Field Safety Notice

Commercial name of the Affected Product:	Convenience Kit of Trilly Oxygenator
Ref. to FSN Number:	FSN 01-2019
Ref. to FSCA Number:	FSCA 01-2019
FSN Title:	Connectors accessories included into Convenience Kit Trilly Oxygenator not correctly and safely assembled
Affected Products:	TRILLY PEDIATRIC
Affected Product detail:	EU6582 Convenience KIT Trilly in following devices: TRILLY PEDIATRIC
Type of action FSCA	Advice given by Manufacturer regarding the use of the device – Instruction for use integration
Type of action FSN	Communication to customer and/or users sent out by a Manufacturer in relation to a FSCA 01/2019.

Subject: **FSN- Field Safety Notice concerning connector accessories inserted in Trilly Oxygenator Convenience Kit**

Figure 1

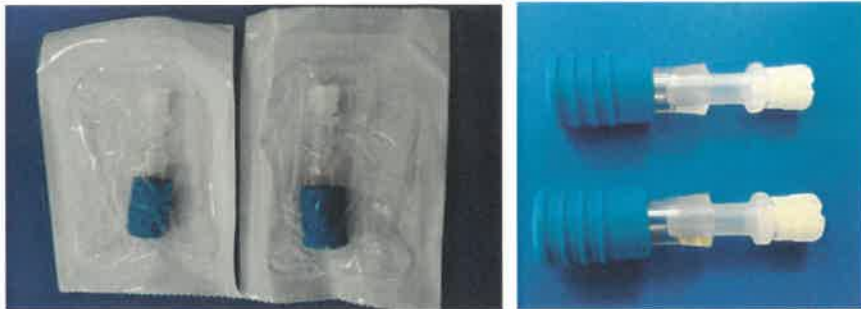
That the 2 additional connectors accessories (*indicated in Figure 1*) allowing that to add luer port on the reservoir, could be defective as not correctly assembled/glued with risk of disconnection with might cause of blood leakage.

This is a preventive action related only to the specific connectors described in Figure 1 in order to prevent any incident or adverse event.

Eurosets recommends not to use the two connectors reported in the Figure 1.

Nevertheless, for safety reasons, Eurosets asks the operators not to use the connectors.
